# UNITED STATES PATENT AND TRADEMARK OFFICE

APPLICATION NO.	FILING DATE	FIRST NAMED INVENTOR	ATTORNEY DOCKET NO.	CONFIRMATION NO.
10/782,656	02/18/2004	Robert McCarthy	200311470-1	5486
22879 7590 10/22/2007 HEWLETT PACKARD COMPANY P O BOX 272400, 3404 E. HARMONY ROAD INTELLECTUAL PROPERTY ADMINISTRATION FORT COLLINS, CO 80527-2400			EXAMINER MCCLAIN, GERALD	
			ART UNIT 3653	PAPER NUMBER
			MAIL DATE 10/22/2007	DELIVERY MODE PAPER

## Office Action Summary

## **DETAILED ACTION**

Fig. 1

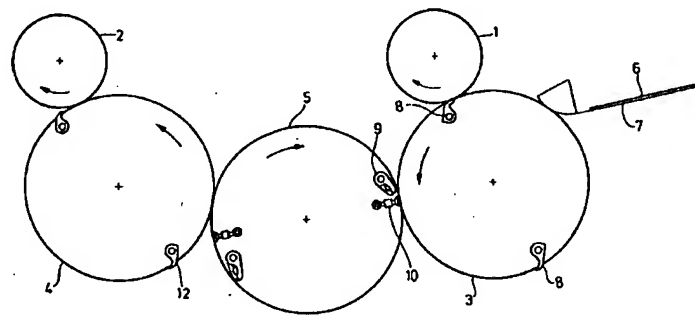
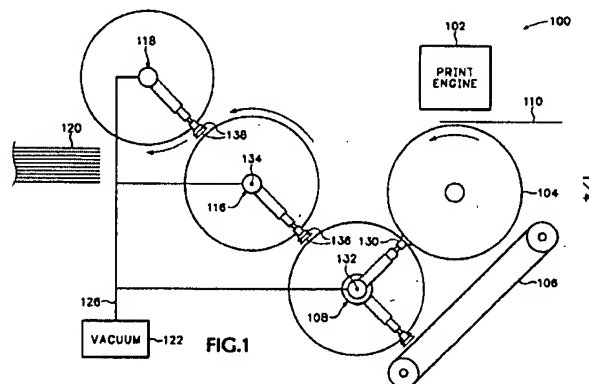
Claims 1 and 4: support (See Fig. 1, concentric circles on 10); cups (10);

Claim 1: distal surfaces (10); conveyor (4); drum (3);

Helmstaedter does not directly show a first plane, a second plane, at least four suction members arranged with the middle cups being in the first plane and the outer cups in the second plane, or a liquid electrophotography print engine.

Krueger shows a similar device having a first plane and a second plane (Fig. 7) for the purpose of "eliminating the disadvantages of earlier machines and to provide at the same time a simplified construction which will be more economical to build and will afford less trouble during operation than has heretofore been practical" (page 1, column 1, lines 18-23). Therefore, it would have been obvious to a person having ordinary skill in the art at the time the invention to modify Helmstaedter as taught by Krueger and include Krueger's similar device having a first plane and a second plane for the purpose of "eliminating the disadvantages of earlier machines and to provide at the same time a simplified construction which will be more economical to build and will afford less trouble during operation than has heretofore been practical".

Tajima shows a similar device having at least four suction members arranged with the middle cups being in the first plane and the outer cups in the second plane (66a-66e) for the purpose of balancing the medium [sic] in the printing device. Therefore, it would have been obvious to a person having ordinary skill in the art at the time the invention to modify Helmstaedter and Hudson as taught by Tajima and include Tajima's similar device having at least four suction members arranged with the middle
